IFALPA ADO Committee Meeting 出席報告 (2017.5.23-25 Montreal, Canada)

IFALPA AIRCRAFT DESIGN AND OPERATION (ADO) COMMITTEE MEETING
BOMBARDIER HQs, MONTREAL, 23-25 MAT 2017**AGENDA ITEM C.6** **MANUFACTURERS**
BOMBARDIER DHC8-Q400 INCIDENTSPREPARED BY ALPA JAPAN

DHC8-Q400 の操縦席と Bleed Switch の位置 (赤い矢印)

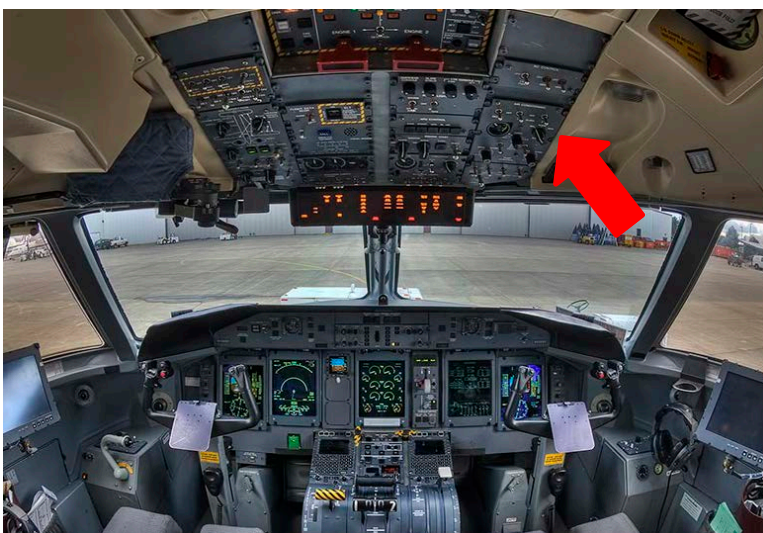
(2) **Bleed Switch** の形状及び緊急状態に至る前でパイロットに注意喚起するシステムについて
 日本で DHC8-Q400 型機を運航している ANAWINGS 及び日本エアコミューターでは、過去に Bleed Switch を OFF Position のまま上昇を続けていった結果、Warning System が作動したケースが散見されています。これは、通常操作では複数回に亘って Switch Position を確認する手順になっているものの、Bleed Switch の場所及び形状に起因したパイロットの見落としが根本的な原因と思われます。そこで、ALPA Japan ADO 委員会は以下の対策を実施することを提案します。

- ① Bleed Switch は運航に不可欠なものであるにも拘わらず、その Switch は小さく Switch の On/Off を容易に視認するのは困難である。そこで Switch の位置を明確に把握出来るよう、Switch を大きなサイズに変更するか、新デザインとすること
- ② 現在の客室高度監視システムにおける Warning / Caution System としては、客室高度が 9,800ft に到達した時に操縦席において Warning System が作動するのみである。そこで客室高度が 9,800ft へ到達する前に、付加的な Caution System (Message あるいは Light) を設置すること

「この問題に関しては以前にも取り上げられたことがある。現在、Bleed Switch の視認性向上について技術セクションが検討を行っており、何らかの変更を予定している」

Figure 3:

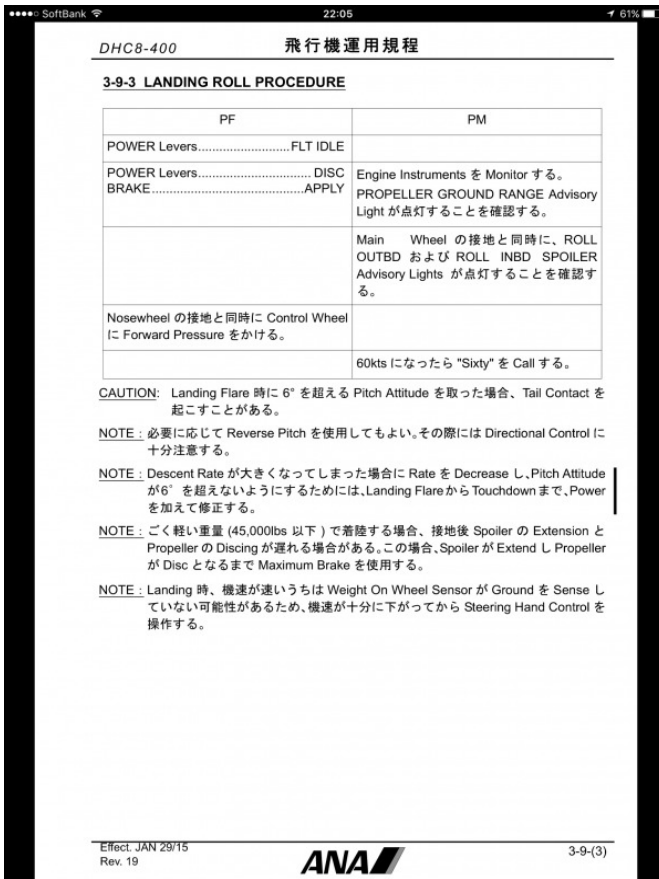
ALPA Japan ADO Committee has discussed this issue and concluded that either the current normal procedure where PM checks the light for the “DISC” on/off while landing roll should be revised, or the position of the “DISC” light be relocated, in terms of the cockpit “Design” and “Operation”.

1. When PF is on the left seat, left seat pilot checks and calls “light on” after setting “DISC” position and PM/right seat pilot monitors. Or,
2. The position of the “DISC” light should be relocated to the center area of the glare shield which can be viewed by both pilots. Then, either one of the pilot/PF operates “DISC” while landing roll and another pilot/PM could monitor the light.

「この件に関しては、日本の国土交通省運輸安全委員会と協力して事故原因の調査中であることから、コメントについては差し控えたい」
